5. COA-044093-2018

508 W Broad St

Commission of Architectural Review

STAFF REPORT

Figure 3. 508 West Broad Street, 1980.

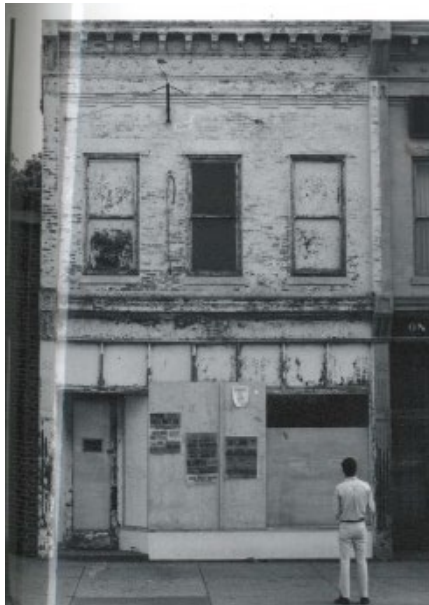
Historic Masonry #1, pg. 63	<i>Do not paint historic brick or stone masonry that has not previously been painted. Painting previously unpainted masonry is historically inaccurate and is not permitted.</i>	<p>The applicant is proposing to paint the entire brick building beige with beige trim. The second story of the rear elevation and the side of the building which was formerly a shared wall with an adjacent building are unpainted. The unpainted brick on the side wall appears to be in disrepair. Though staff does not typically support the painting of unpainted masonry, this wall was not intended to be an exterior wall and is in poor condition so staff supports the painting of the wall in this particular case. <u>Staff recommends the unpainted brick on the rear of the building not be painted.</u></p> <p>The applicant is also proposing to paint the window sills, doors, and door trim green. Green is an approved trim and door color and <u>staff recommends approval of painting the doors and trim. However, any unpainted masonry sills should remain unpainted. Previously painted masonry sills should be painted a color consistent with the Commission's paint palette. Paint details should be submitted to staff for administrative review and approval.</u></p>

- The unpainted brick on the rear of the building not be painted.
- Any unpainted masonry sills remain unpainted and previously painted masonry sills be painted a color consistent with the Commission's paint palette. Paint details be submitted to staff for administrative review and approval.
